Description: Data Requests for Mojave Solar Project (09-AFC-05C) Addition of Two New Evaporation Ponds

Petition To Amend: TN#253750, TN#253751, TN#253752

May 6, 2024

MSP Two New Permanent Evaporation Ponds-Data Requests- Responses

Appendix 1

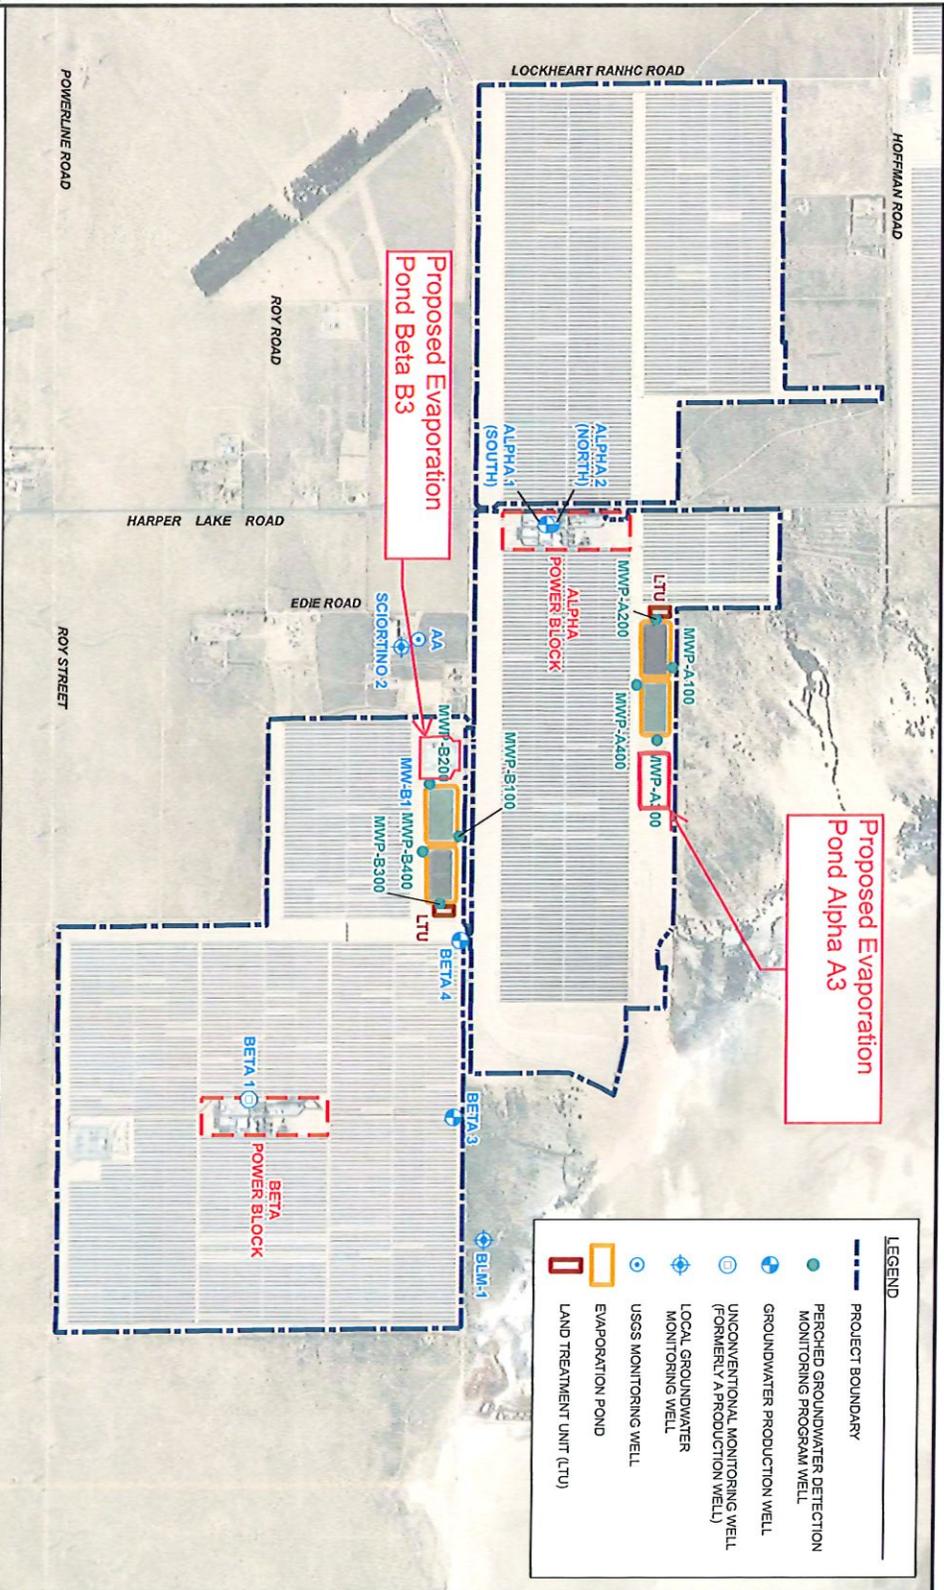
9. Please document the nearest downgradient water table groundwater monitoring well, including how far away it is and how close (directionally) to being directly downgradient based on flow direction in the water table aquifer. This could be documented on a figure showing the evaporation ponds with an arrow pointing to the downgradient water table well with the distance listed, and another arrow showing the flow direction in the water table aquifer.

See Appendix 1, as provided in the July 30, 2023, Detection Monitoring Program/ Groundwater Monitoring Plan (prepared by Ninyo & Moore). The distance from the proposed Beta Pond to existing downgradient wells are provided. There are currently no monitoring wells downgradient of the proposed Alpha Pond.

Appendix 2

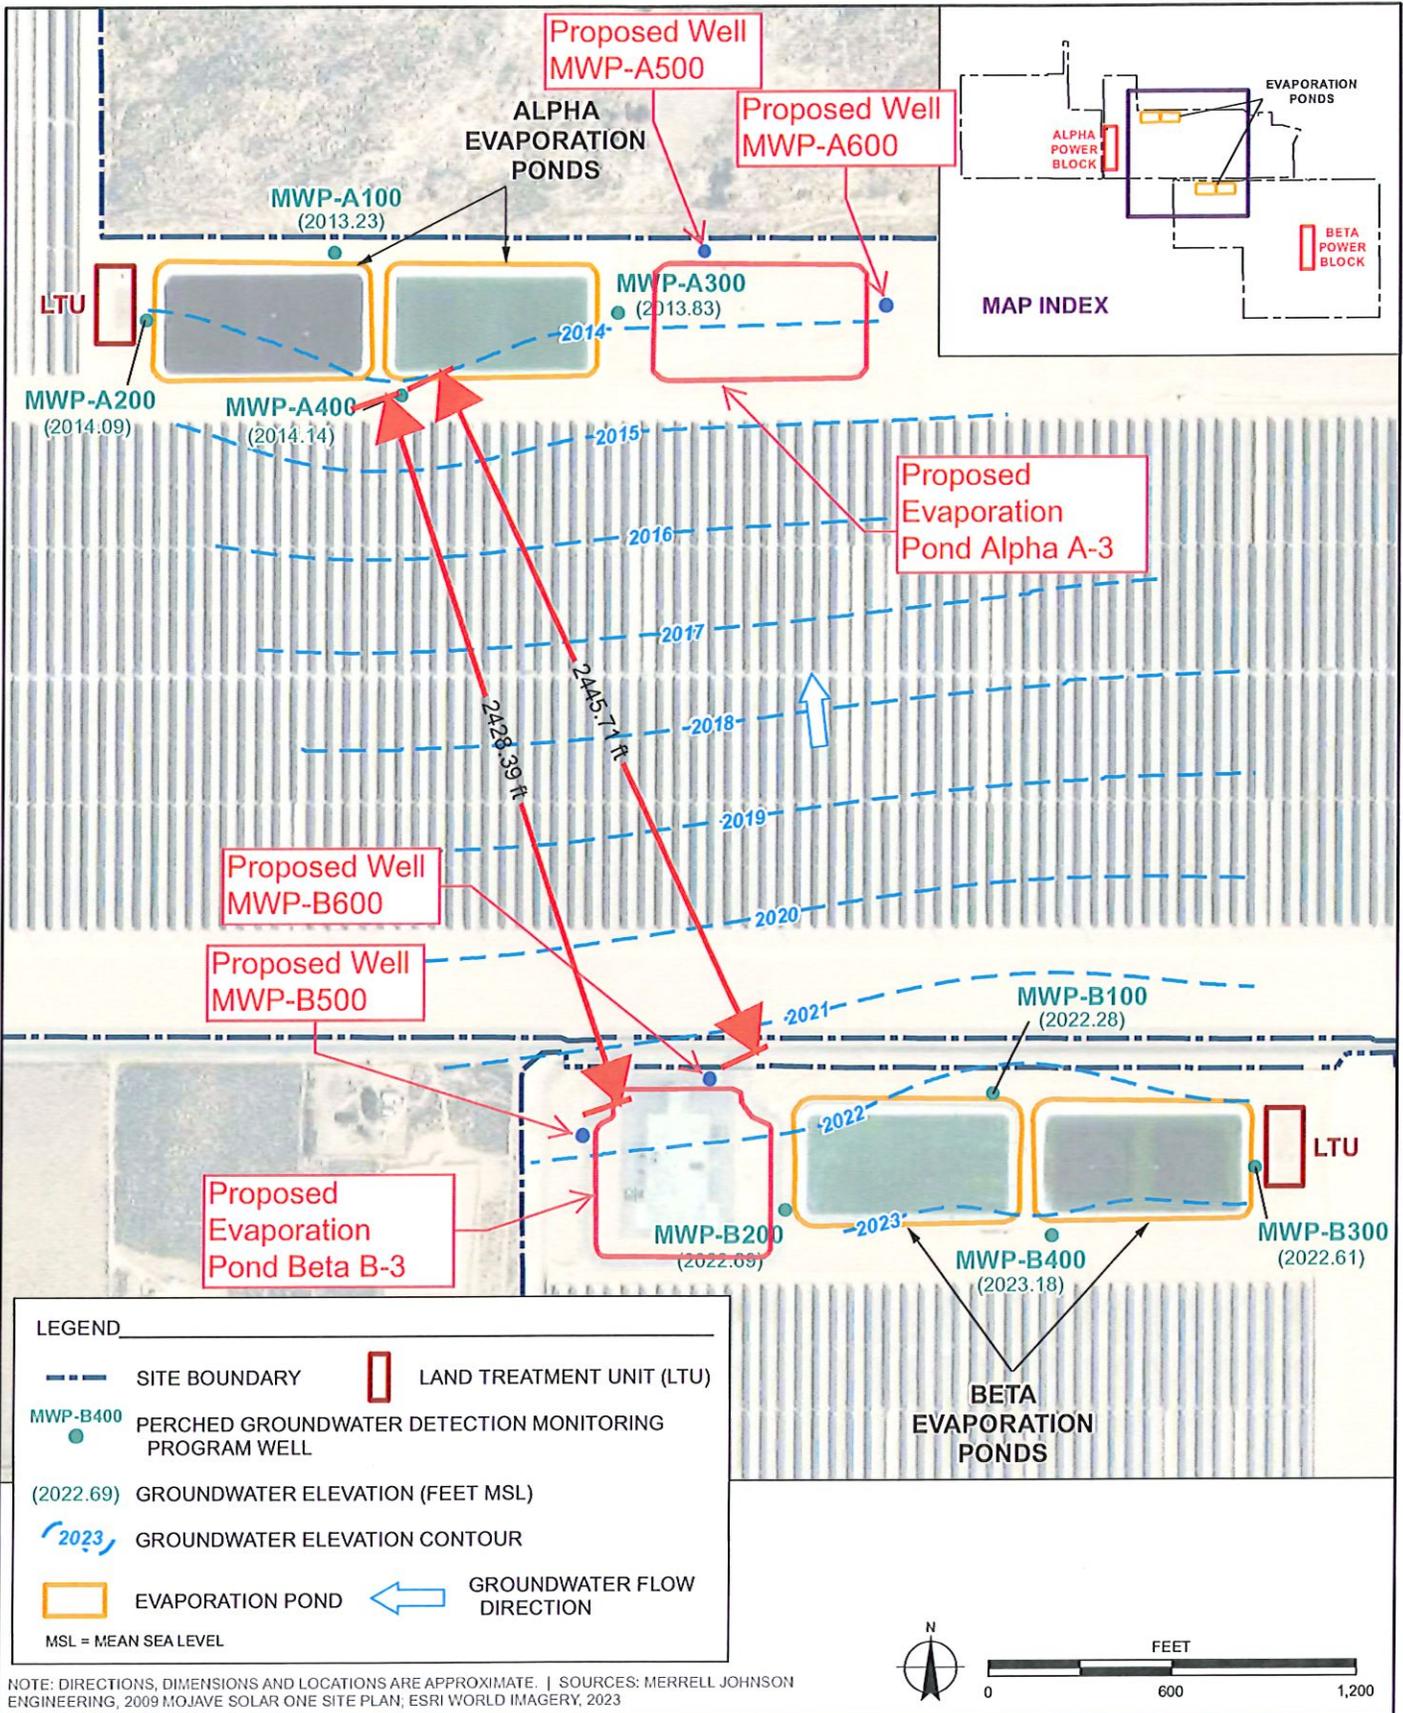
8. Please provide the groundwater flow direction for the perched groundwater zone on a figure showing the evaporation ponds and the proposed perched groundwater monitoring wells to better document that the proposed wells are located appropriately.

See Appendixes 1 & 2 which depict the existing evaporation ponds, existing perched groundwater monitoring wells, proposed evaporation ponds, and proposed perched groundwater monitoring wells. The perched groundwater contours are based on the data provided in the July 30, 2023, Detection Monitoring Program/ Groundwater Monitoring Plan (prepared by Ninyo & Moore).

Appendix 3

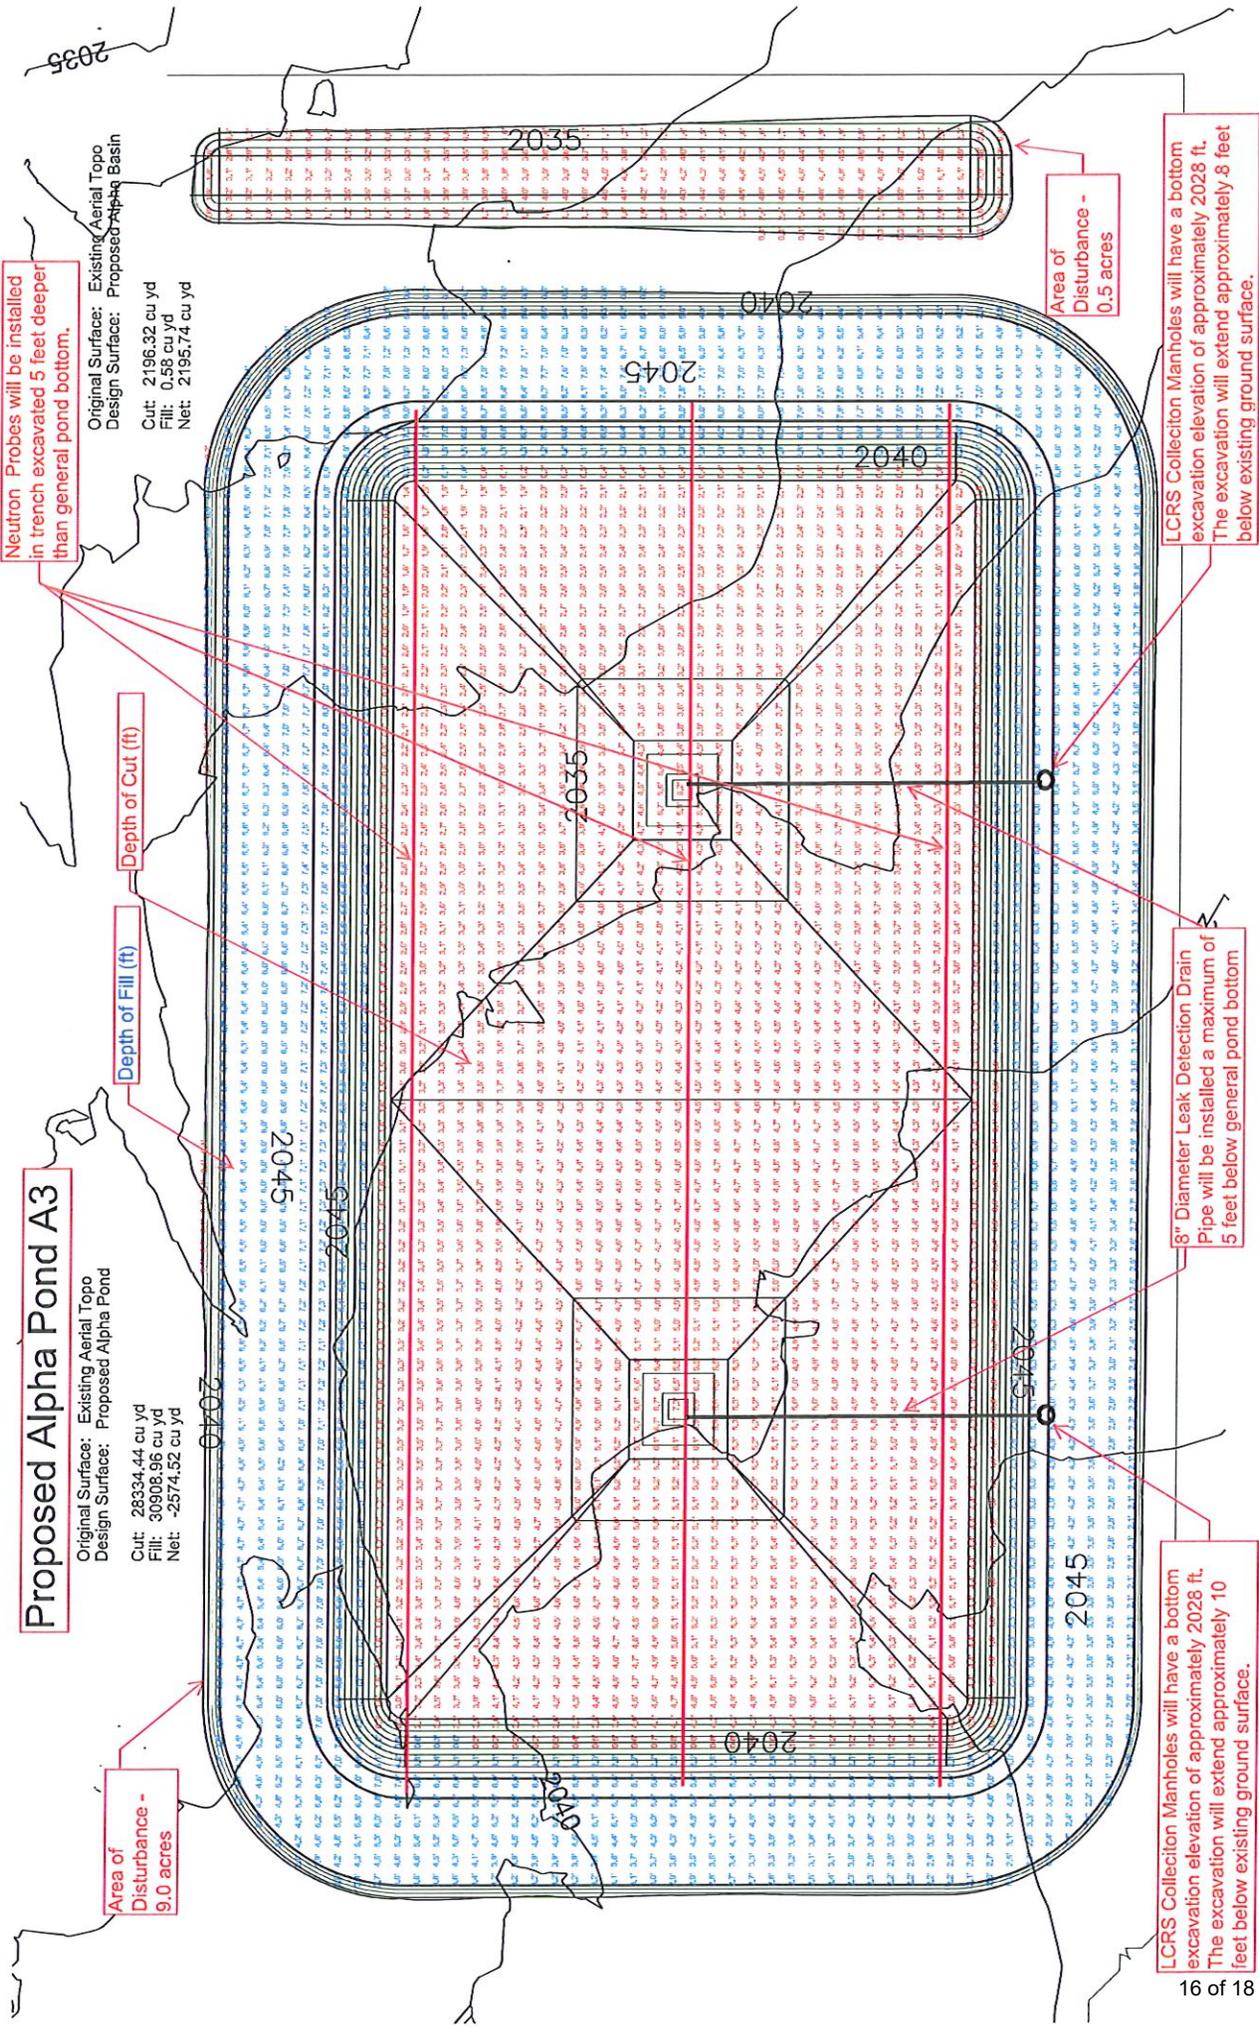
3. Please describe and characterize the scale of excavation (particularly depth) required for various project components, including:
 - a. Demolition of existing concrete foundation and pavement at the site of the mirror assembly building
 - b. Alpha and Beta ponds (with maximum depths of excavation identified for the liner system, sumps, leak detection pipes and manhole, and wastewater force main pipeline and control valves).
 - c. Perched groundwater monitoring wells.
 - d. Stormwater runoff retention basin.

3b. See Isopach figures (Appendixes 3 and 4) showing the Depth of cut and fill for the Alpha and Beta ponds. Depths are shown in feet below the existing ground Surface. The area of disturbance is also provided on the figures. Features within the pond limits are shown and depths of cut listed. The wastewater force main pipeline and control valves will be nominally 4 feet below existing ground Surface.

3d. The Isopach figure for Alpha Pond (Appendix 3) shows the Depth of excavation for the stormwater runoff retention basin and area of disturbance.
